AGENDA ITEM #2

TO: Design Review Commission

SUBJECT: 14-SC-29 – 1251 S. Springer Road

Approve design review application 14-SC-29 subject to the findings and conditions

SOUTH SIDE ELEVATION

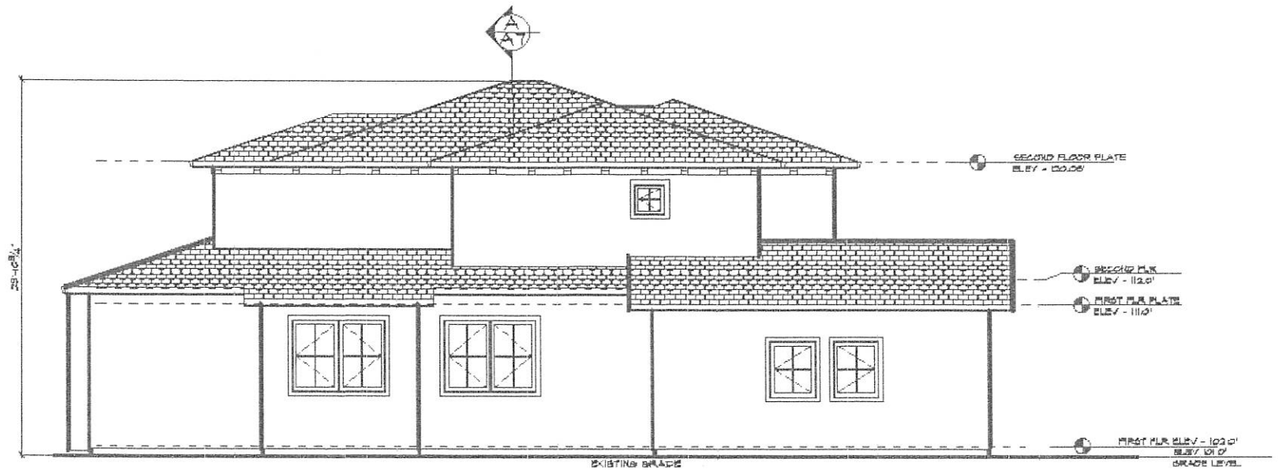
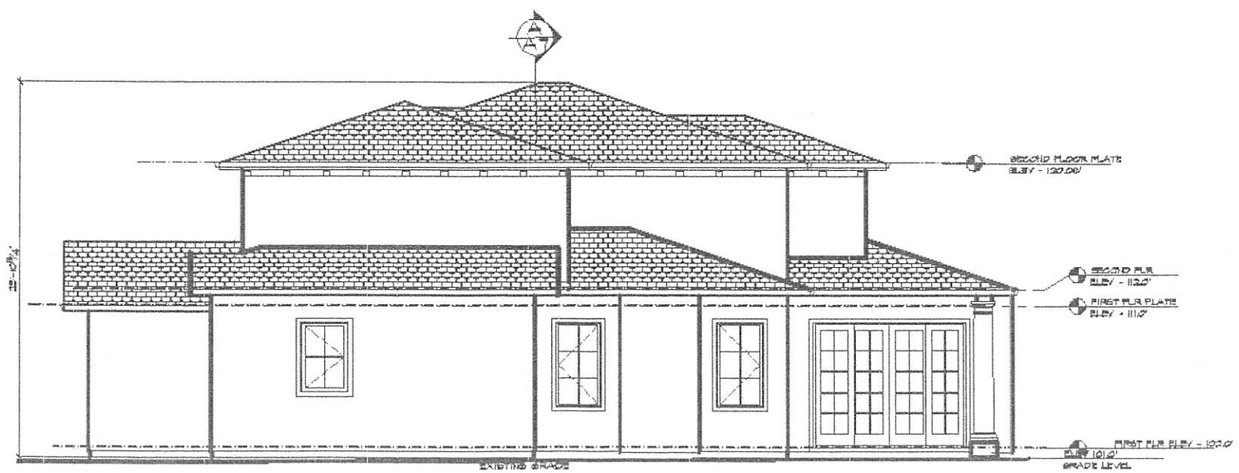
The proposed two-story structure uses a design approach that has some traditional elements, such as a two-car garage and covered entry; however, the design appears out-of-scale with the surrounding neighborhood primarily due to its massing. The immediately surrounding neighborhood has a smaller scale, with one-story structures with low eave lines and wall heights. Additionally, given the simplicity of the surrounding structures, the proposed structure is more complex in massing than the adjacent homes. The two-story high walls and scale of the proposed structure as well as the tall wall plates creates an abrupt change. Furthermore, the proposed second story massing does not appear as integral to the overall design concept. The exterior design appears to be based on the floor plan and appears "inside-out." The City's Residential Design Guidelines suggest designing a house from "outside-in" rather than the reverse as it tends to lack a clear overall design and often adds to the perception of excessive bulk. This approach produces a more complex massing and unusual wall and roof forms such as the transition between the roof and the second story shown on the south side elevation.

The commissioners discussed the project and stated general concerns with regard to mass and bulk, that the elevations needed improvement to minimize bulk, that the windows need to be simplified and cohesive, that the side elevations could have some windows to improve the quality, and the the front elevation is the most problematic being too massive and complex in its design.

The applicant has revised the plans to meet the recommended direction. The revised design simplified the complex massing and roof forms and incorporated additional materials that help to break up the two story elements and exposed walls. The changes include:

- A stone wainscot and stone on the garage facade;
- A new roof form was added between the first and second story across the front;
- Hipped roofs over the garage and the projecting element on the right side of the first story;
- Hipped roofs over the projecting elements at the second story;
- The windows were resized on the front of the house to better relate to one another;
- Window were added at the second story facing the side property lines;
- The rear second story roof has been simplified; and
- The eave height on the right side of the front facade was lowered.

The first story roof overhang and the new hipped roof elements at the first and second stories are the most substantial revision made to the front facade that help to reduce the bulk and massing. The original design included two-story height walls and gable roof ends facing the front, both of which accentuated the height of the structure. The horizontal first-story eave line and simplified hip roofs minimize the bulk at the first story. The second story was articulated to provide two smaller hip roof elements with the main roof set back farther.

The rear and side elevations are substantially the same; however, the roof plan was revised to include hipped roof forms on the right side which help simplify the design. The rear elevation was simplified by staggering the hip roofs in smaller forms that minimize the bulk from the rear.
